**Proposal for draft amendments to document TRANS/WP.29/GRSG/2005/8
(Regulation No. 107)**

"Figure 20
TESTING DEVICE FOR SITING OF HANDHOLDS
(see Annex 3, paragraph 7.11.2.1.)

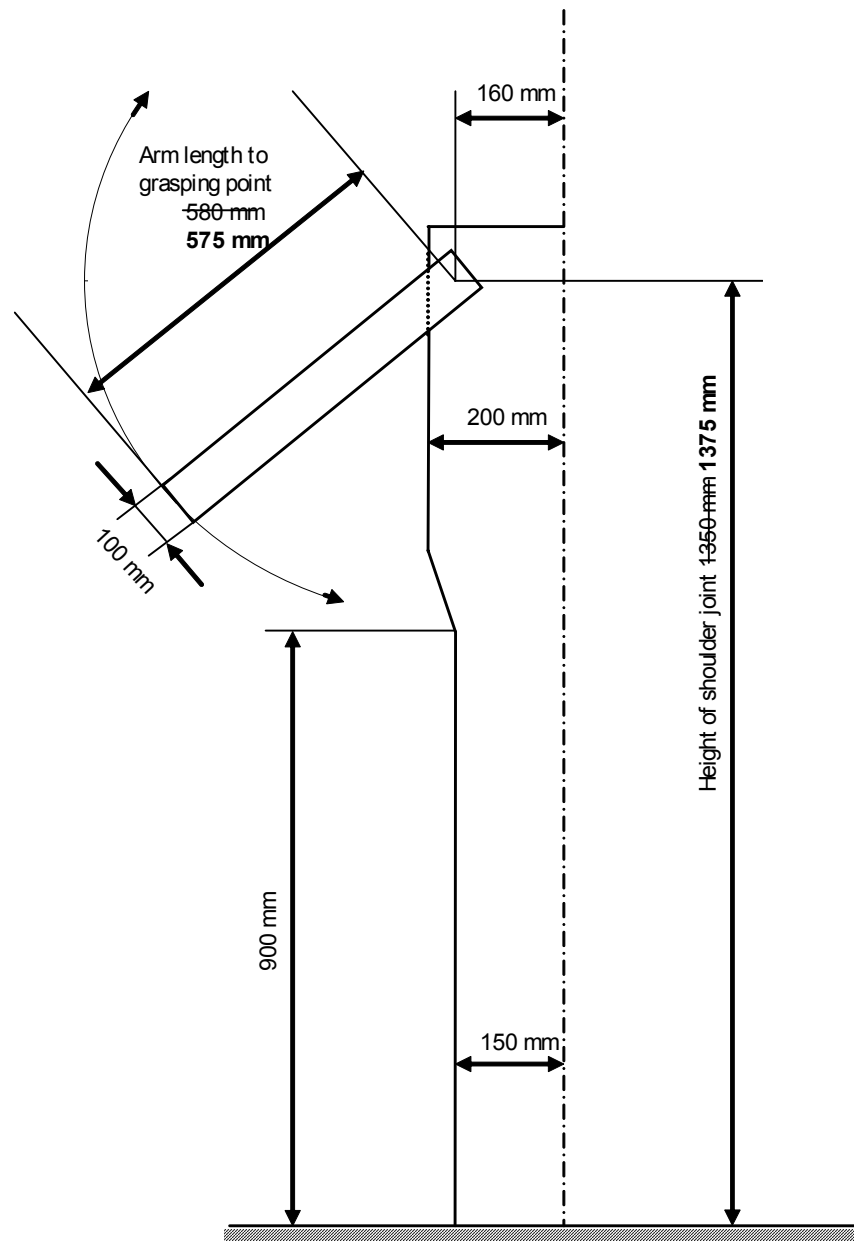
Figure 20, amend to read:

As requested under item 16 of the report on the eighty-eight session the drawing was changed to match the agreed amendment contained in TRANS/WP.29/GRSG/2005/8.

Thickness: 20 mm."
